Supporting Document A (SD A) Technical Study Report Introduction

APPENDIX SD A-1
Response to Comments Received on Draft Technical Study Reports
(Prior to Draft License Application Filing, August 2024)

Stakeholder Comments on Draft Technical Study Reports and Associated SCE Responses

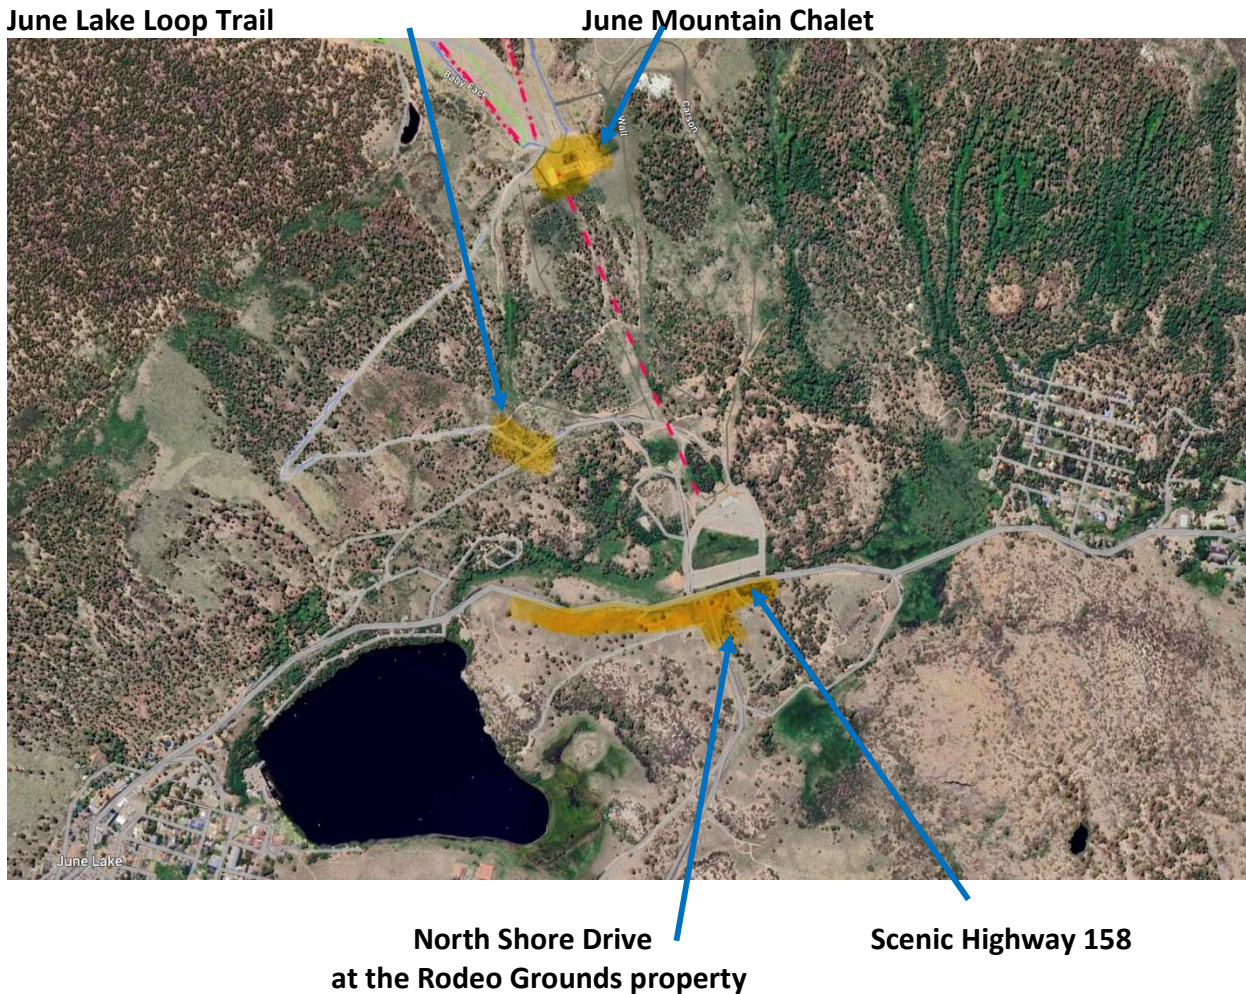
Recommended Additional KOPs. The Rush Creek project is a large and long-term undertaking that will occur in a small community that is economically dependent on summer recreation and for which SR 158 is the sole through-arterial highway. Due to its central location within the loop, the proposed June Mountain Base of Operations has potential for significant adverse impacts to the visual and recreational resources on which the June Lake economy is based. These potentially significant impacts cannot be mitigated unless they are first analyzed with the careful consideration already given to the dam areas. For this reason, TSR LAND-2 (Aesthetics) should be expanded to include visual simulations and analyses for KOPs associated with the proposed June Mountain Base of Operations.

The four KOP locations recommended by Mono County for the expanded study simulations include:

- (1) June Lake Loop Trail
- (2) Mid-Chalet on June Mountain (where events are held and scenic chairlift rides terminate)
- (3) Scenic Highway 158 (viewing west on approach to the ski area parking lot)
- (4) North Shore Drive (where it approaches from the Rodeo Grounds property).

A map is provided on the following page to show the general vicinity of these recommended KOP locations. Each of the identified sites will require field verification to determine the most representative viewpoint.

Commenter	Comment No.	Date Received	Study Plan	Comment	SCE Response
Mono County	Mono-Aesthetics-09	6/27/2024	LAND 1 – Aesthetics Technical Study Report	<p>Recommended Additional KOPs. The Rush Creek project is a large and long-term undertaking that will occur in a small community that is economically dependent on summer recreation and for which SR 158 is the sole through-arterial highway. Due to its central location within the loop, the proposed June Mountain Base of Operations has potential for significant adverse impacts to the visual and recreational resources on which the June Lake economy is based. These potentially significant impacts cannot be mitigated unless they are first analyzed with the careful consideration already given to the dam areas. For this reason, TSR LAND-2 (Aesthetics) should be expanded to include visual simulations and analyses for KOPs associated with the proposed June Mountain Base of Operations. The four KOP locations recommended by Mono County for the expanded study simulations include:</p> <p>(1) June Lake Loop Trail (2) Mid-Chalet on June Mountain (where events are held and scenic chairlift rides terminate) (3) Scenic Highway 158 (viewing west on approach to the ski area parking lot) (4) North Shore Drive (where it approaches from the Rodeo Grounds property).</p> <p>A map is provided on the following page to show the general vicinity of these recommended KOP locations. Each of the identified sites will require field verification to determine the most representative viewpoint.</p>	Refer to response to Mono-Aesthetics-05.

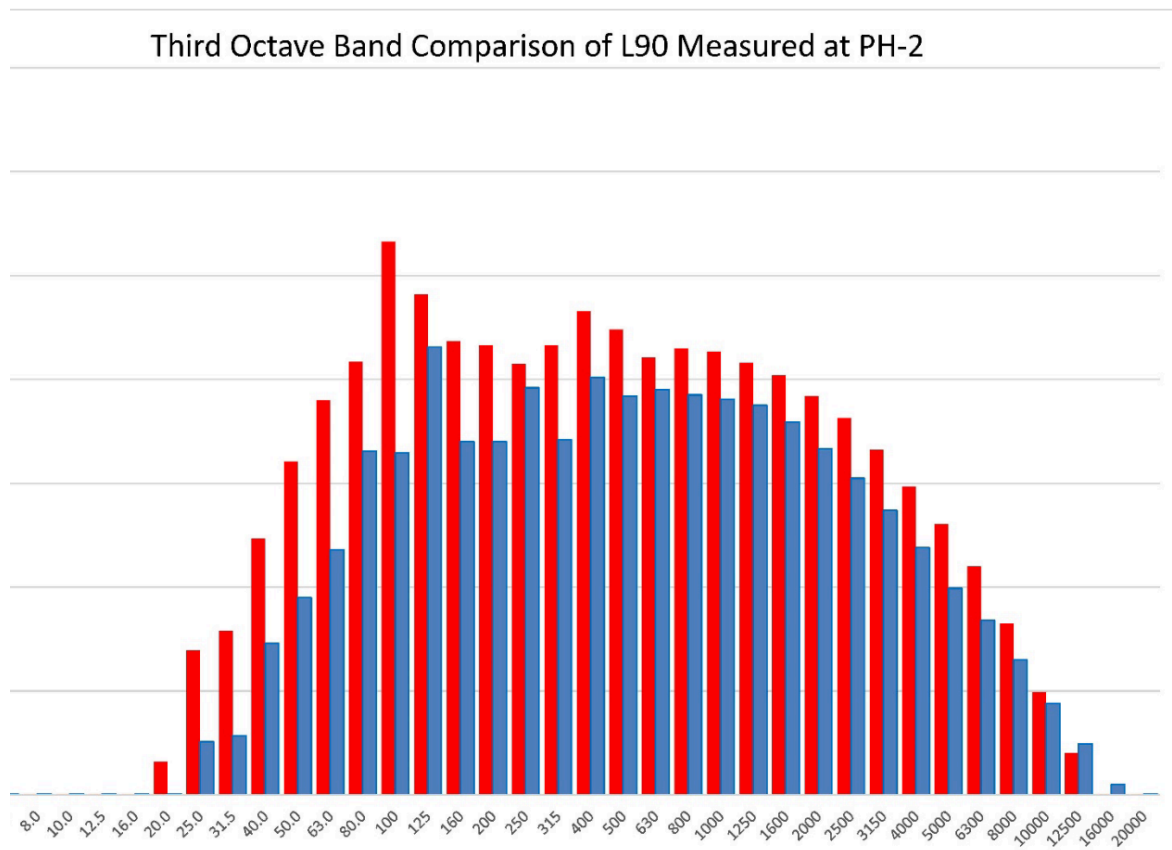
These comments are to bring forth concerns over two aspects of the noise issue with respect to the powerhouse: the spectral resolution of the noise measurements as presented in the study report, and the interpretation of the impact of the noise from a psychoacoustic aspect.

In the graph above, an indistinct noise peak can be seen in the range of 100Hz.

Due to the limited spectral resolution in the above graph, it is impossible to discern that this is clearly a tonal noise.

Commenter	Comment No.	Date Received	Study Plan	Comment	SCE Response
David S. Rosky	Rosky-01	6/10/2024	LAND 2 – Noise Technical Study Report	<p>Summary:</p> <p>In summary, the following requests are made regarding the powerhouse noise portion of the LAND-2-Noise study:</p> <p>1. That powerhouse noise study data be presented to stakeholders with sufficiently high spectral resolution to accurately characterize tonal noise, as shown in the example of the second chart above. If insufficient spectral resolution was recorded, some measurements should be retaken, enough to characterize the actual spectral content of the noise.</p> <p>2. A psychoacoustic evaluation of the noise should be performed to avoid an oversimplified conclusion of the degree to which the noise may cause stress or discomfort based only on absolute amplitude or loudness.</p> <p>The spectral resolution of the powerhouse noise measurements, at least as presented in the study report, are inadequate to discern the type of noise which is the cause of greatest concern in the vicinity of the powerhouse. The study report presented noise measurement result graphs with a spectral resolution of one-third of an octave. This resolution is inadequate to fully discern and characterize narrow-band tonal noise, a type of noise which human perception is extremely sensitive to. From a psychoacoustic perspective, a tonal noise that is well below the noise floor can be easily perceived, and if it is audible and present for long periods of time, can have significant negative psychological impacts. The presence of audible narrow-band tonal noise can be considerably more important than the magnitude of such noise relative to other non-tonal noise, such as white or pink noise, that may be present. During certain operational conditions, highly audible tonal noise is emitted from the tailrace exit of the powerhouse, particularly when power is being generated at lower flows. The presence of this was captured to some degree in the study measurements, but not to a degree necessary to characterize its possible impacts.</p>	<p>In regard to powerhouse noise: The LAND 2 Noise TSR filed with the Final License Application will include a finer resolution of the frequency spectrum of the noise emanating from the powerhouse, in a format similar to the example provided by the commenter.</p> <p>In regard a psychoacoustic evaluation of powerhouse noise: The details of the noise Technical Study Plan (TSP) were developed iteratively based upon stakeholder input in 2023, which included changes to: add measurement points of interest near residences; add measurement points of interest at various angles from the powerhouse tailrace; and add an additional “no power generation” measurement condition. Because the LAND 2 Noise Technical Study Plan did not specify preparation of a psychoacoustic evaluation and no such request was made during development of the Technical Study Plan, this request falls outside of the scope of work of this study. In addition, a psychoacoustic evaluation is not needed for NEPA and FPA purposes and won't inform the development of license conditions.</p>

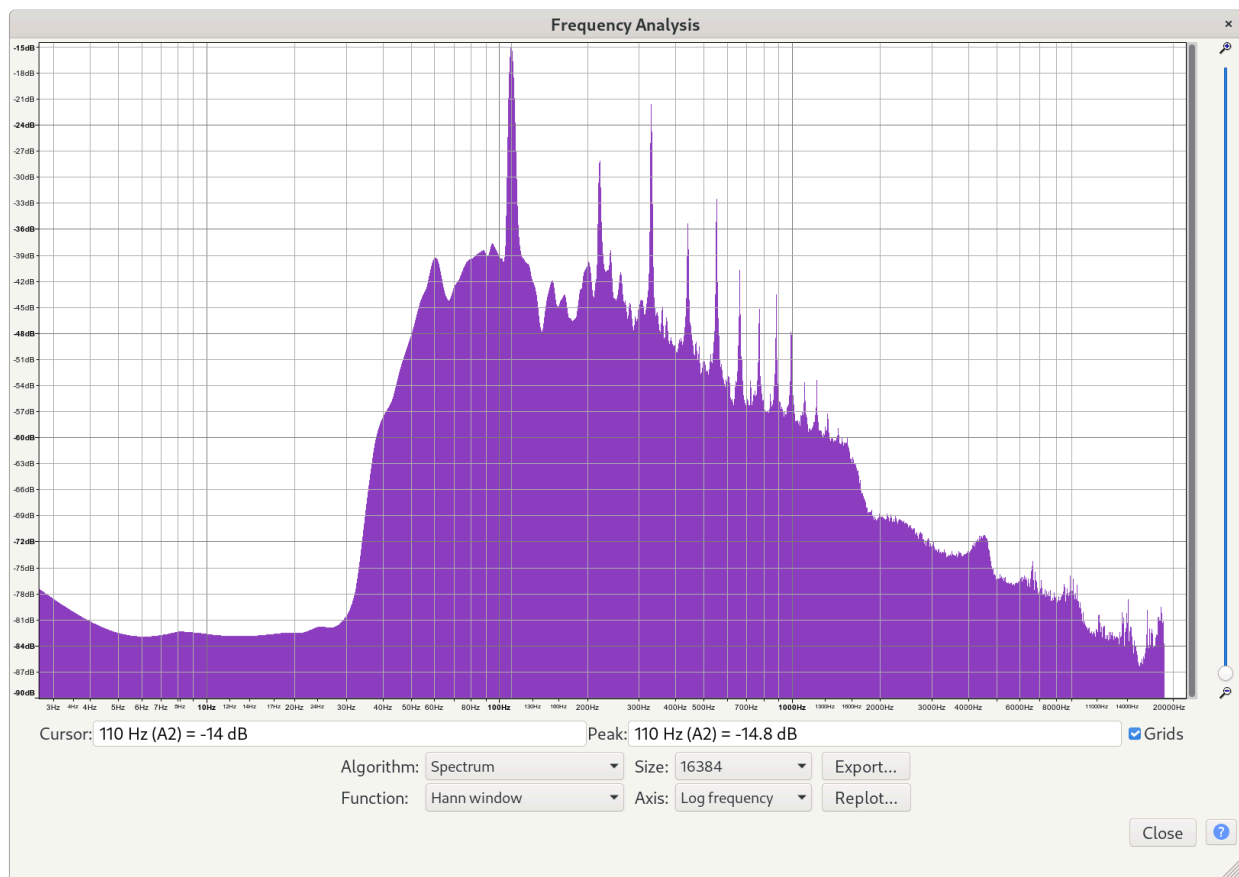
Below is a chart based on recordings that I made at a previous time from a location on Highway 158 close to the powerhouse tailrace:

This chart, presented at much higher spectral resolution shows clear tonal noise at the same frequency of approximately 100Hz, which is **25dB larger in magnitude than the pink background noise**. There are also numerous tones present at other frequencies which barely present at all in the graph included in the study report.
